ENGINE - LP COMPRESSOR - NEW FAN CASE ASSEMBLY WITH IMPROVED ACOUSTIC LINING -
CATEGORY CODE 6 - MOD.ENG-72-0249

V2500-ENG-72-0249

SERVICE BULLETIN

Location of the Fan Case Assembly
Fig.1

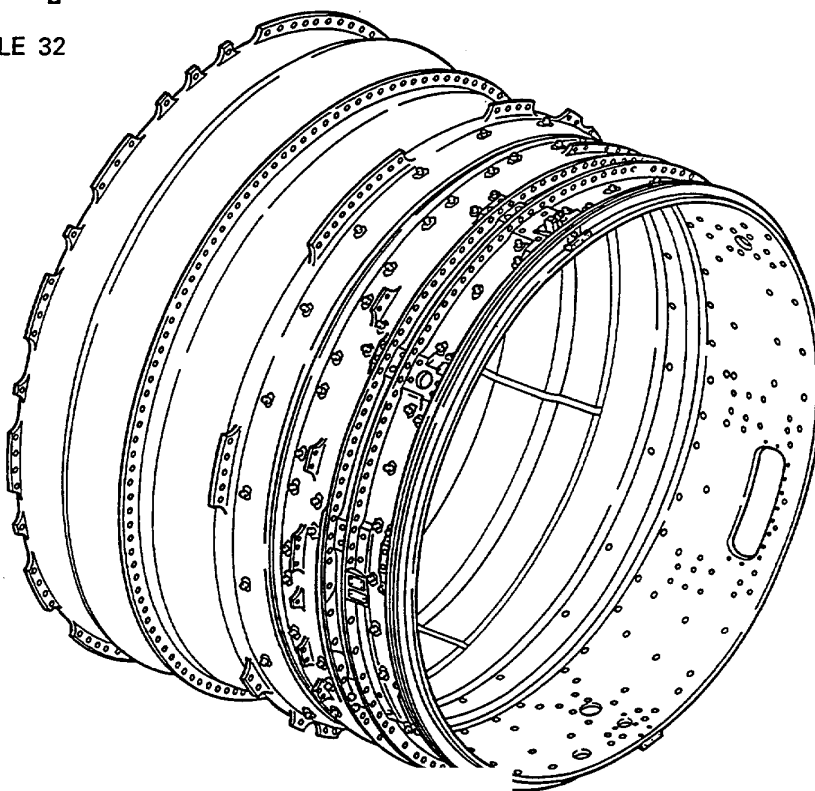
To improve the perforation skin and reduce the chances of the skin unbond.

This bulletin introduce the fan case assembly with improved the perforated skin.

- (1) Assemble new 5W0168 (A1 Engines), 5W0169 (A5 Engines) and 5W0170 (D5 Engines) fan case assembly by use of approved procedures Engine Manual, 72-32-00 Assembly.
